VANGUARD GARMENTS LTD

20 October 2025

2. Observation:

IMRF is considered in the analysis model

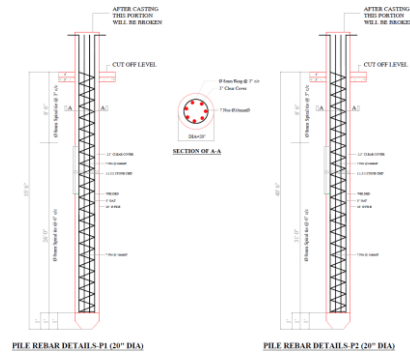
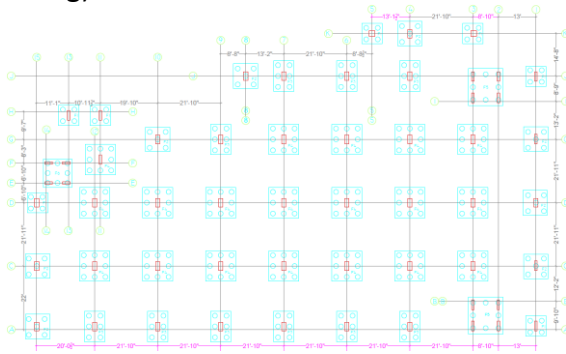
Insufficient concrete core test report

Lack of re-bar test report

Description: A design report has been prepared for the 9-storied Main Production Building. Several inconsistencies were observed in the DEA report.

- Steel rebar strength was 500 MPa (72.5 ksi), considered in the design report without any test report.
- Factory collected six core samples (four from columns, one from a beam, and one from a slab). However, during inspection, the core locations could not be identified, and no core layout plan was available. Additionally, the number of cores tested for the beams and slabs in the submitted report is insufficient.
- The Intermediate Moment Resisting Frame (IMRF) system was adopted in the software-based analysis without proper justification. Necessary checks must be incorporated to confirm the IMRF framing system and ensure it does not adversely affect structural irregularities.

The Building Engineer is required to verify the actual material strengths and revise the design documents based on verified data and the actual framing system and submit to RSC for detailed review against lateral loadings.

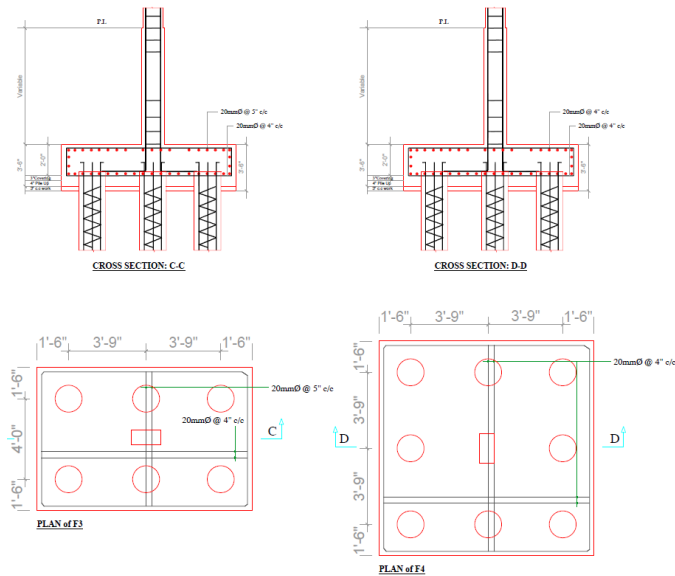
There are two types of pile P1 and P2. But in the pile layout plan pile type was not mentioned.

- Type of pile P1 and P2 not shown in the drawing.
- Grade beam and basement slab levels were not shown in the drawing.
- Structural details of the Overhead water tank U.G.W.R were found missing in the drawing.
- Floor building up in the floor toilet area was not shown fully.
- Floor beam layout was missing at the rooftop level (101.5 ft level). Also, beam layout mismatch was found at grid 8.

The building engineer is required to survey the structural components and produce accurate as-built structural drawings.

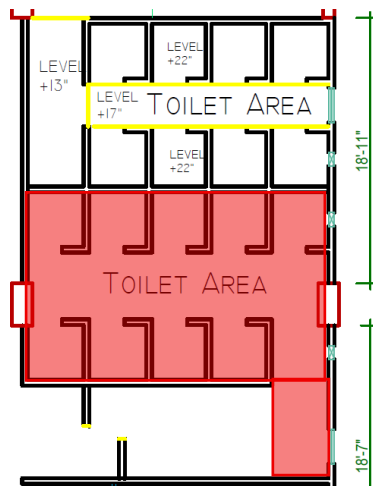
Grade beam and basement slab level was not shown in the drawing

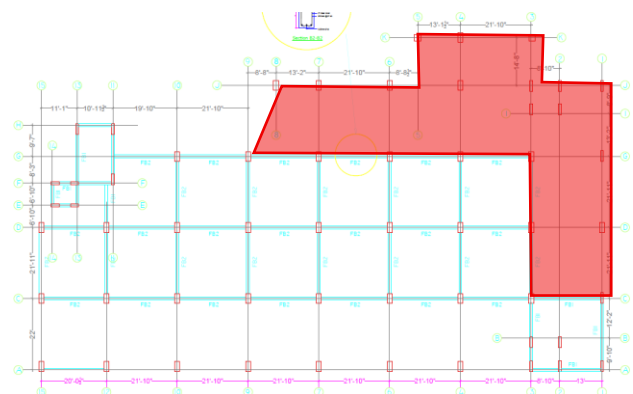
In the marked area floor build-up was found, but not shown in the drawing

Beam layout missing at marked area at top level (101.5 ft level).

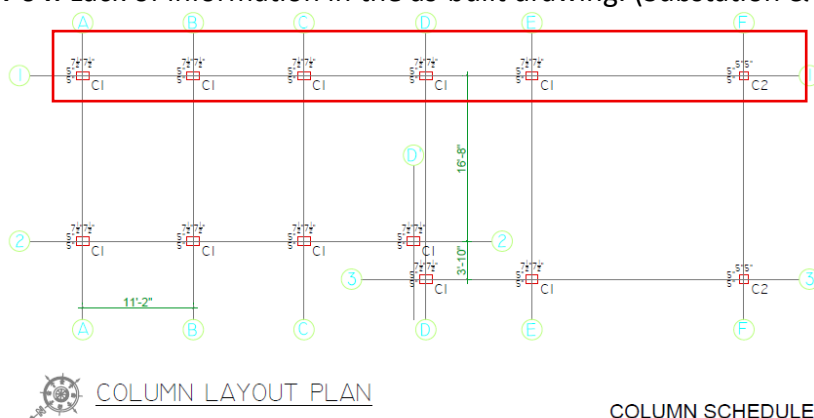
Lack of structural information of O.H.W.T. and U.G.W.R

Observation-04: Lack of information in the as-built drawing. (Substation & Generator Building)

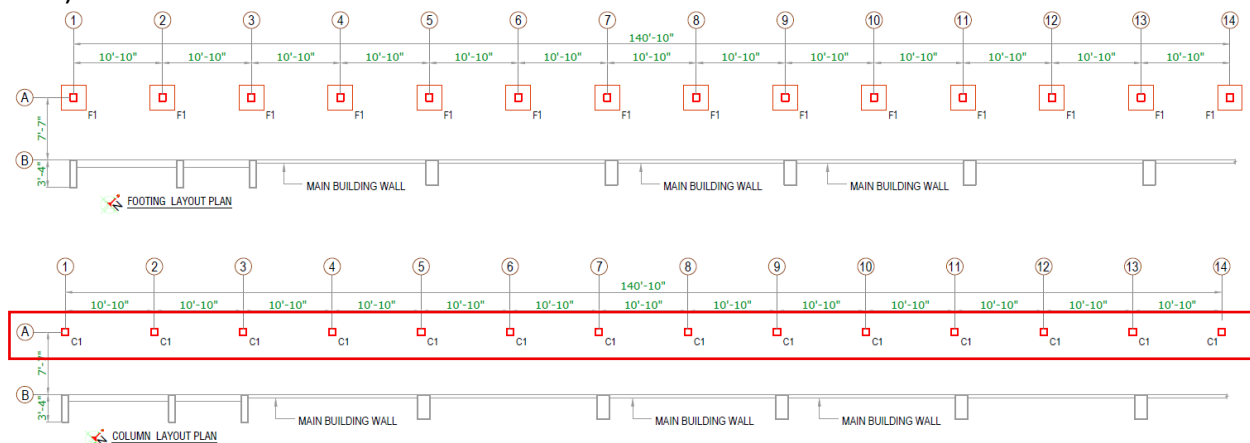
Description: During inspection, lack of information was observed between drawings and the existing condition. The grid dimension was found missing in the provided as-built drawing. The building engineer is required to survey the structural components and produce accurate as-built structural drawings.

Prayer, Gas Meter & Security Room

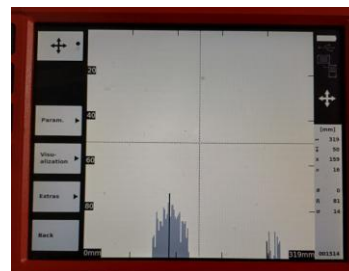
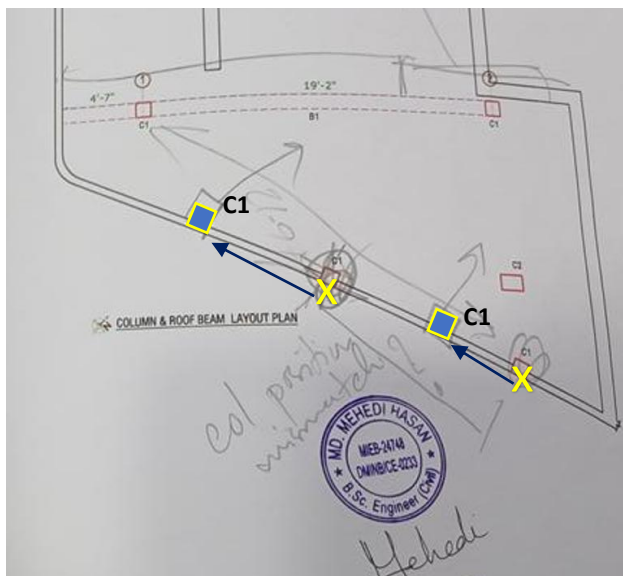
Description: As per BNBC, every building or structure designed shall have its design documents prepared under the provisions of Section 1.9.

At the time of inspection, no design report and material test reports were available on-site. Building engineer is required to prepare a safety check report.

Observation-08: Discrepancies in the as-built drawing. (Fire Pump Room)

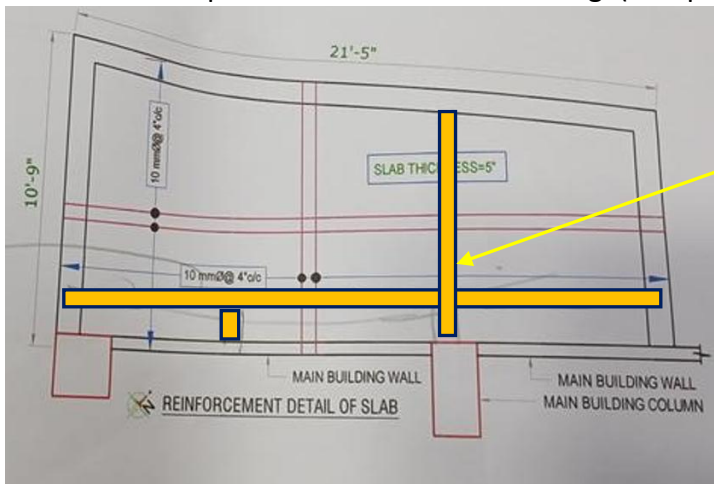
Description: During inspection, mismatches were observed between drawings and the existing condition. At the inclined grid, grid distance and position of the marked columns were found changed from the as-built drawing. Also, during inspection 4 rebars was found at C1 column instead of 8 rebars. The building engineer is required to survey the structural components and produce accurate as-built structural drawings.
